UNITED STATES OF AMERICA
NUCLEAR REGULATORY COMMISSION

In the Matter of §
§
HOUSTON LIGHTING & POWER §
COMPANY §
§
(Allens Creek Nuclear §
Generating Station, Unit §
No. 1) §

Docket No. 50-466

APPLICANT'S FURTHER ANSWERS TO TEXPIRG'S
SIXTEEN 'H' INTERROGATORIES

FIGURE 5.2-7

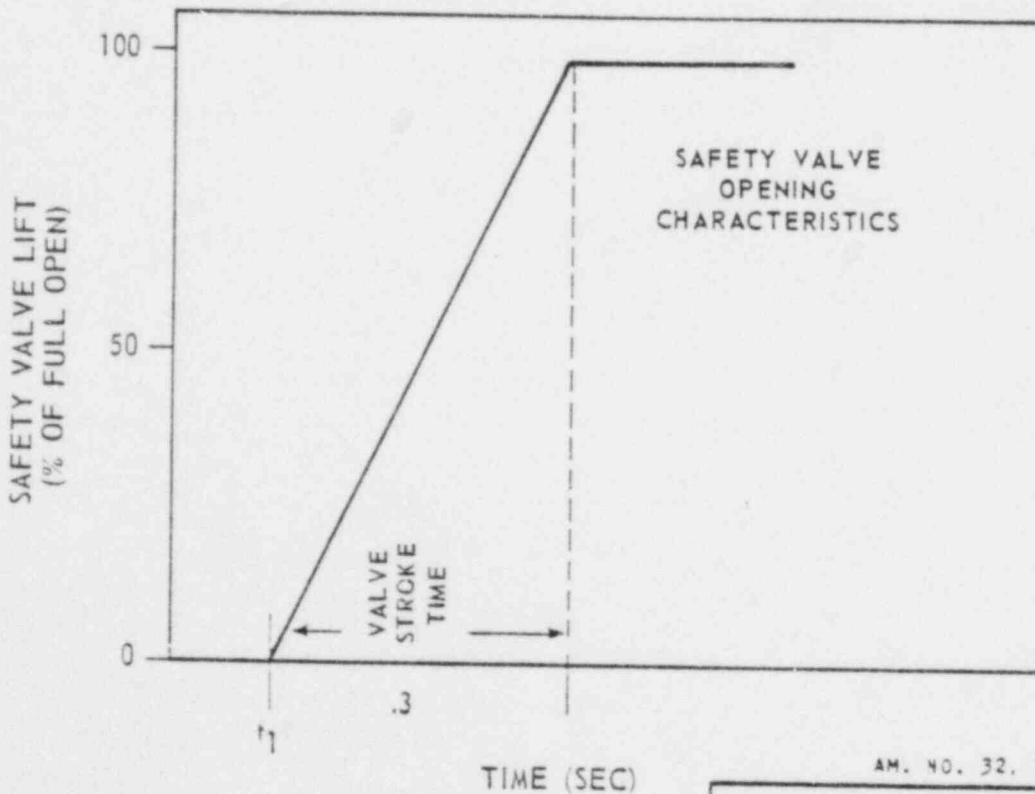
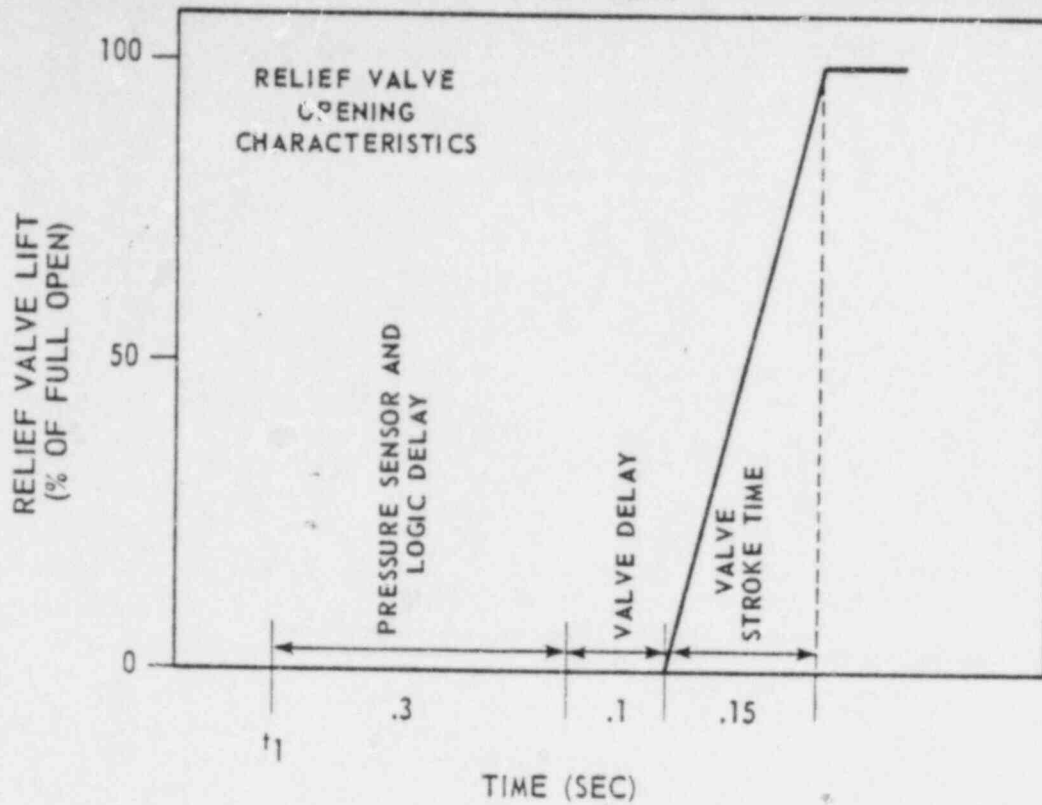
What is the time delay of the ACNGS pressure sensing system? Valve Assembly? What is the accuracy of these times? What is the range of times associated with the slowest to fastest valves? Slowest to fastest sensing system?

As explained on p. 5.2-11 of the PSAR, for the limiting overpressure transient (MSIV closure with high flux scram), the analysis assumes that one of the 1105 psig set point safety/relief valves fails and that 50 percent of the

remaining valves in each set point group open in their power-actuated, relief mode. In this mode, the valves are opened by a pneumatic operator. The other 50 percent fail to open in the relief mode, and are assumed to open (if needed) in their self-actuated, spring mode. In the spring mode, the reactor pressure acts to lift the relief valve against a spring. Obviously, if all of the valves open in their power-actuated, relief mode, a less severe transient pressure spike is produced than predicted by analysis because the delay time to open the valves would be shorter. Hence, with regard to the overpressure protection analysis, the delay times are conservatively assumed.

Figure 5.2-7 (Attachment 1) shows the delay times assumed in analysis.

FIGURE 5.2-1

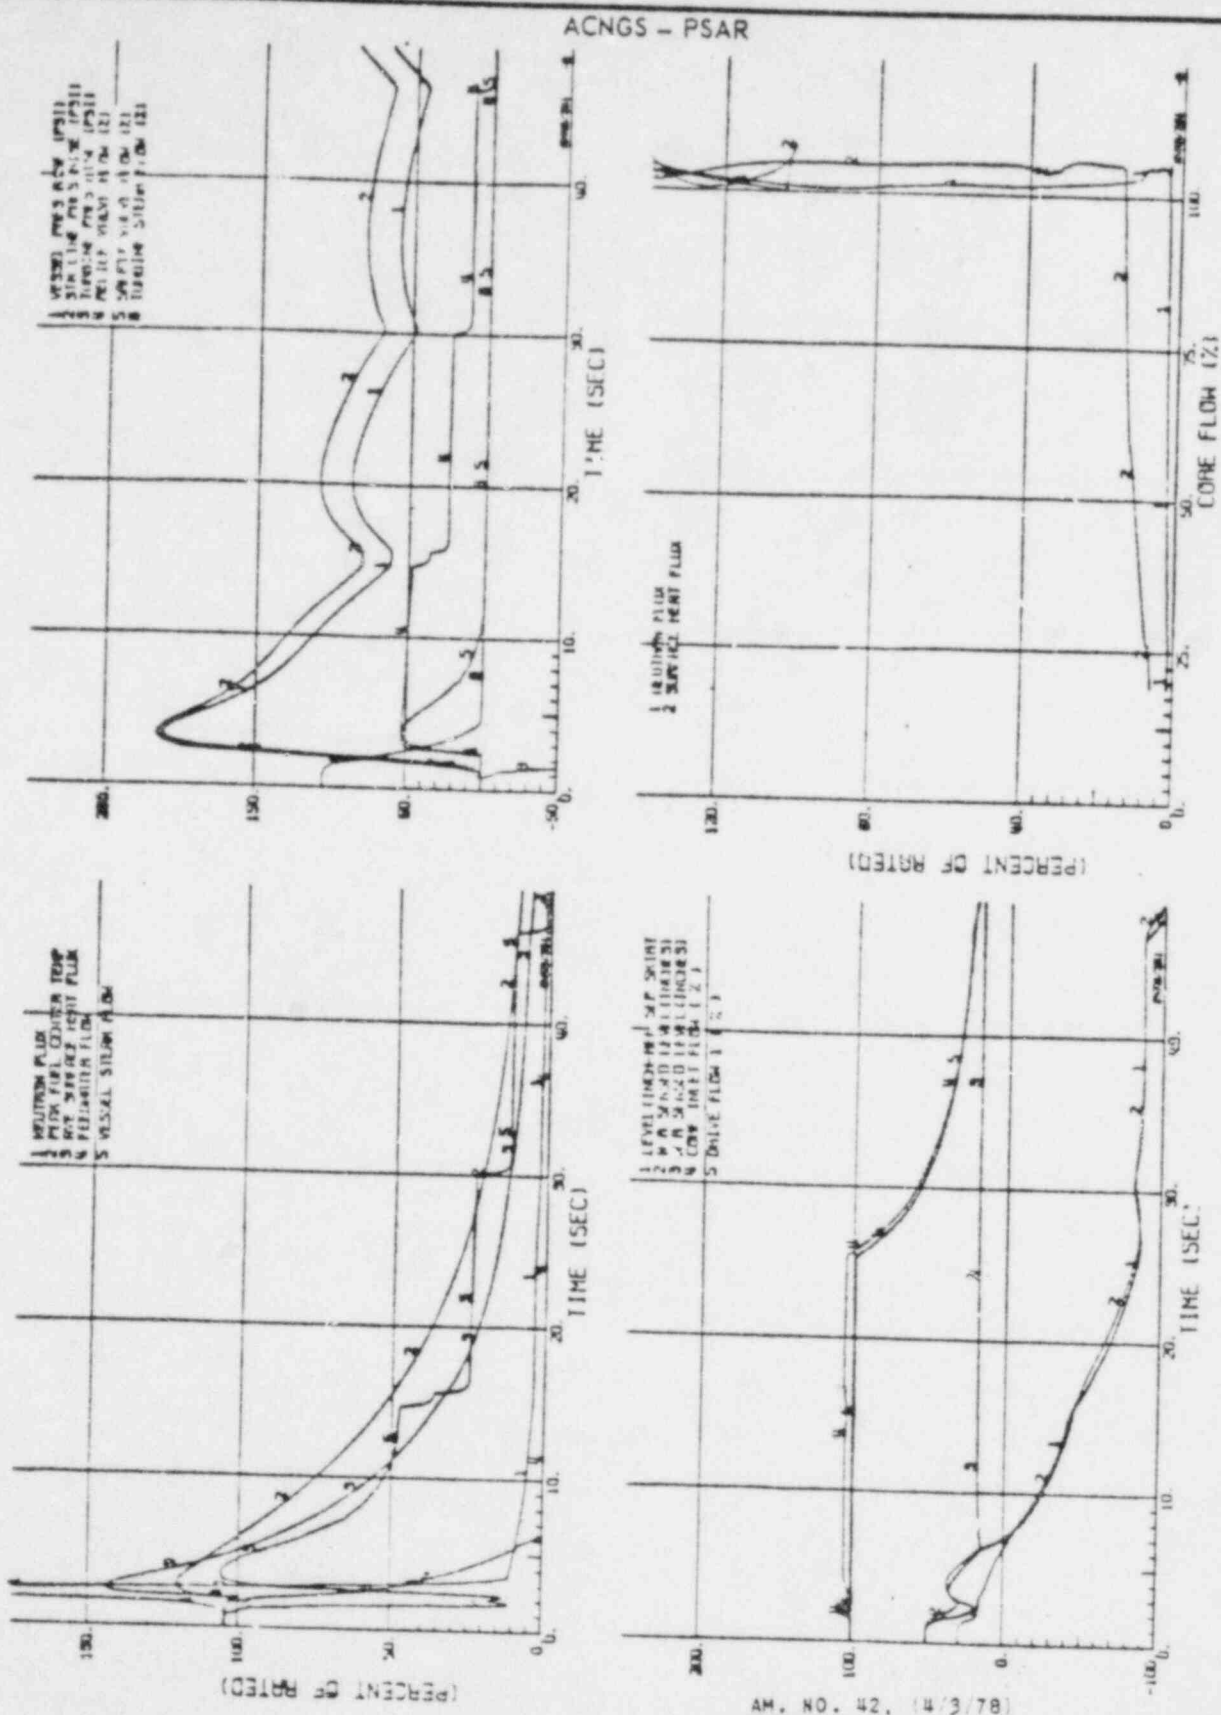
What is the rate of change of pressure with time near the 1300 psi level of the transit under the conditions assumed? What would the resulting pressure be if it is assumed that all relief valves were delayed by (a) 0.1 sec. and (b) 1.0 sec. in opening past the times assumed in the analysis?

Figure 5.2-1 of the PSAR (Attachment 2) shows pressure as a function of time for the design basis overpressure event (MSIV closure with high flux scram). For interpreting this figure, rated pressure for ACNGS is 1045 psig.

In the design basis overpressure analysis (MSIV closure) one safety/relief valve is assumed not to open, half the remaining valves are assumed to open in the spring relief mode, and scram is assumed to not occur from MSIV closure even though a redundant, safety class position indication system would generate a scram signal as the Main Steam Isolation Valves close. Instead, scram is assumed delayed until a high flux signal occurs. Under these assumptions, considerable delay beyond that normally expected has been factored into the analysis. Obviously, still more delay could be postulated. However, such additional delay would be unreasonable in light of the conditions already assumed.
